MEMORANDUM

DATE: March 6, 2023

RE: Project Updates
SEH No. 170120 14.00

RE: Peninsula Road Restriping Recommendations
SEH No. 170120 14.00

MCM 5: Post-Construction Stormwater Management

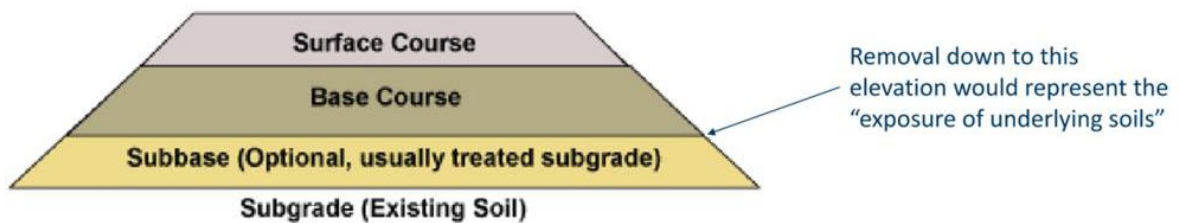
With the current rules in place, any excavation below the top of subgrade would require storm water treatment to be added to the project. Attached to this memo is a graphic from the MPCA illustrating how much excavation is allowed before the ponding is needed.

Here is a graphic from MPCA. Basically if we expose the subbase – that would trigger the stormwater requirements for Medicine Lake.

Figure 2: Recommended revisions to the 2022 striping plan for Peninsula Road.

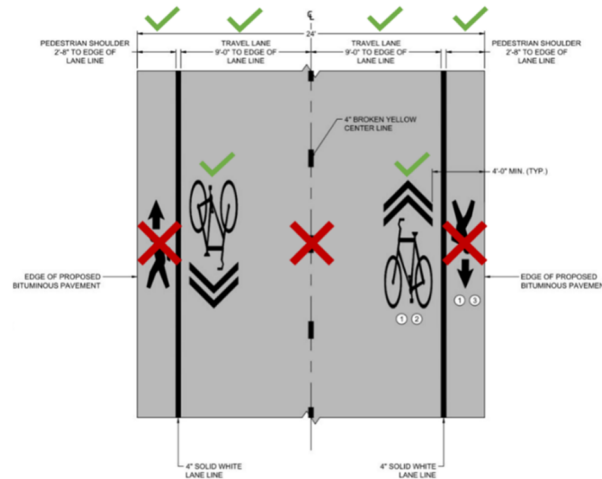
The 2022 striping plan was reassessed to simplify the markings while also achieving an improved complete streets design treatment along Peninsula Road. The recommended changes to the 2022 striping plan are summarized in Figure 2 and adhere to MnMUTCD standards. A discussion for each design decision is provided below.

Minnesota State Statute 8820.9926, Minimum Design Standards: Rural and Suburban Undivided; Reconditioning Projects, states that the minimum lane width for a paved roadway is 10 feet for a low-volume, low-speed roadway. However, based on the roadway's context, City goals, surrounding land use, and low-volume characteristics, engineering judgment has been made to reduce to 9-foot travel lanes to allow space for shoulders. Peninsula Road is a non-State Aid route and therefore does not require a variance for this lane width reduction.

It is not recommended to include a broken yellow centerline primary due to the roadway context and surrounding land use. When the roadway is safe and clear, motorists will be able to encroach on the opposite lane to provide space between non-motorized users on the roadway (e.g., walkers and bikers). This is consistent with similar local, low volume streets in the City. Centerline markings are typically more appropriate on higher-volume collector or arterial roadways, wider roadways, and/or to improve safety.

“Sharrows” indicate to bicyclists and motorists where people biking should ride within a lane. The 2022 striping plan includes these markings on the outside edge of each travel lane, approximately 4-feet from the edge of pavement. Per MnMUTCD Chapter 9C.7, markings should be placed immediately after an intersection and spaced at intervals not greater than 250 feet. These markings are recommended to alert road users of bicyclists that may be within the traveled way and encourage bicyclists to travel in the correct direction.

Consistent with the 2022 striping plan, 3-foot shoulders are recommended to be striped on both sides of the roadway to act as a traffic calming feature for motorists and to provide dedicated space for multimodal activity (e.g., pedestrian activity). Providing shoulders on both sides of the roadway allow pedestrians to walk in the counterflow direction of traffic and provide a connection to the existing trail and sidewalk networks along S Shore Drive.

It is not recommended to include pedestrian markings since the 3-foot width is below the MnDOT accessibility guidelines for a sidewalk (minimum of 4 feet) and may not allow for safe use of mobility devices.
